III	PROVISION OF TOWER WAGON SIDING.	I. VIDE DY.CSTE/RE/DNR. L.NO. BCRE/S&T/DRG/401/PT-III, DT-31-3.2022 II. E.S.P.NO. C.E's DRG. NO. Y-132-2021 ALT-1	31/3/22 SSE/S/RE/DNR 31.3.22 SSE/D/RE/DNR	01/04/22 ASTE/RE/DNR	DSTE/RE/DNR	DY.CSTE/RE/DNR	06/4/22 DY.CSTE/PLG/HJP		06/04/22 (N. AMBASTHA)	7.4.22 (RISHI GUPTA) CSTE/PLG/HJP

PINK BOOK ITEM NO.-5/2014-15
THIS SIP SUPERCEDED PREVIOUS SIP NO.-ECR/SIP/DHN/518/2017

पूर्व मध्य रेल धनबाद मंडल EAST CENTRAL RAILWAY DHANBAD DIVISION	APPROVED BY	COUNTERSIGNED BY	COUNTERSIGNED BY	CHECKED BY	CHECKED BY	CHECKED BY	CHECKED BY	CHECKED BY	CHECKED BY	CHECKED BY	DRAWN BY	C.R.S. SANCTION NO.	SCALE			
	31/5/18 (SHYAMLAL PRASAD) CSTE/PLG./HJP f CSTE / ECR / HJP	(S.K. PRASAD) CTPM/ECR/HJP FOR COM/ECR/HJP.	10/04/2018 (RAJESH KUMAR) CSTE/C/S/MHX	11/4/18 (AADHAR RAJ) Sr. DOM/DHN	(AJIT KUMAR) Sr.DSTE / DHN	06/04/2018 (A. SINGH) DY CSTE / C /DHN	02/04/18 (B.K. SINGH) DY.CSTE / C / S / MHX	(G. GUPTA) DSTE / CON / MHX	(NEHAL SHAMS) DSTE / CON / MHX	(SHIMLA KUMARI) SSE /SIG/ C / MHX	(O.P.GOND) SSE /DRG/CON/MHX	12/58/VIII/18/252/H DATE :- 25.06.2018 COMPLETED ON 28.10.2018	LONGITUDINAL : 1CM = 10M TRANSVERSE : 1CM = 5M	CENTRAL PANEL (P.I.) SIGNAL INTERLOCKING PLAN

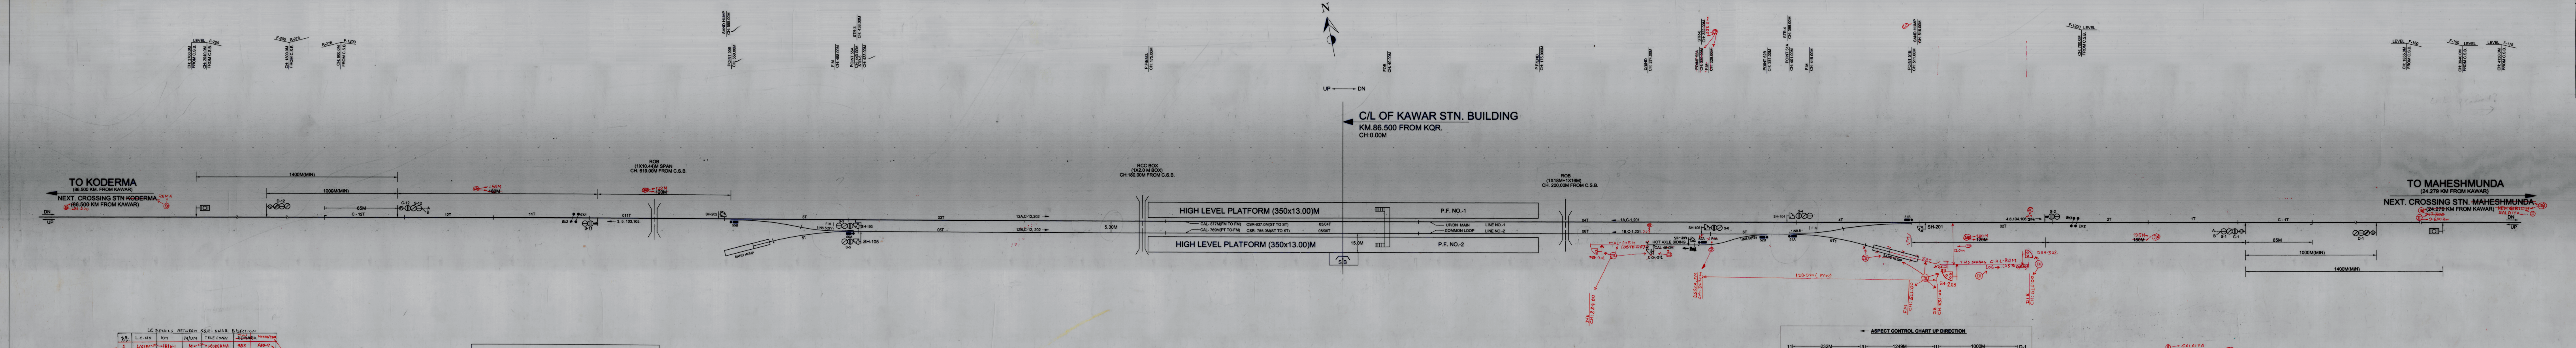
1. ABSOLUTE BLOCK SYSTEM OF WORKING WITH ~~KODERMA & MAHESHMUNDA~~ RENA ⓑ ~~NEW GIRIDIH~~ SALAIYA ⅱ
2. UFSBI BLOCK PANEL WITH HASSDAC WORKING BETWEEN KAWAR-~~KODERMA~~ RENA ⓑ SINGLE LINE TYPE SITUATED IN PANEL CABIN
3. UFSBI BLOCK PANEL WITH HASSDAC WORKING BETWEEN KAWAR-~~MAHESHMUNDA~~ ~~NEW GIRIDIH~~ ⓑ SALAIYA ⅱ SINGLE LINE TYPE SITUATED IN PANEL CABIN
4. ALL ANGLE OF X- ING ARE 1 IN 12 EXCEPT AS MENTIONED IN SIP
5. CONTROL TELEPHONE PROVIDED AT PANEL CABIN.
6. HASSDAC PROVIDED FOR LAST VEHICLE VERIFICATION & INTERLOCKED WITH BLOCK PANEL.
7. LED SIGNAL PROVIDED FOR ALL MACL SIGNALS
8. THIS SIP HAS BEEN MADE TO SUIT 25KV AC TRACTION AREA.
9. THIS SIP HAS BEEN MADE IN CONNECTION WITH NEW BG LINE FROM KODERMA TO GIRIDIH
10. 60 SEC. TIME DELAY PROVIDED FOR CALLING-ON RECEPTION SIG NO. C-1 & C-12.

SL.NO.	INSTRUCTION	ISSUED BY	AUTHORITY	REMARKS
	UNDER THE PROVISION OF GR.PARA 3.40 (1)(b) ADEQUATE DISTANCE OF 120M HAS BEEN RECKONED FROM THE STARTER FOR THE FOLLOWING SIGNAL			
(a)	SIGNAL NO.6 ON LINE NO-2 FOR THE RECEPTION OF DN TRAIN UPTO SAND HUMP.	C.R.S. E/CIRCLE		DISPENSATION TO BE OBTAINED
(b)	SIGNAL NO.5 ON LINE NO-2 FOR THE RECEPTION OF UP TRAIN UPTO ~~SAND HUMP~~. 53T WITH 53 NORMAL. ⅲ
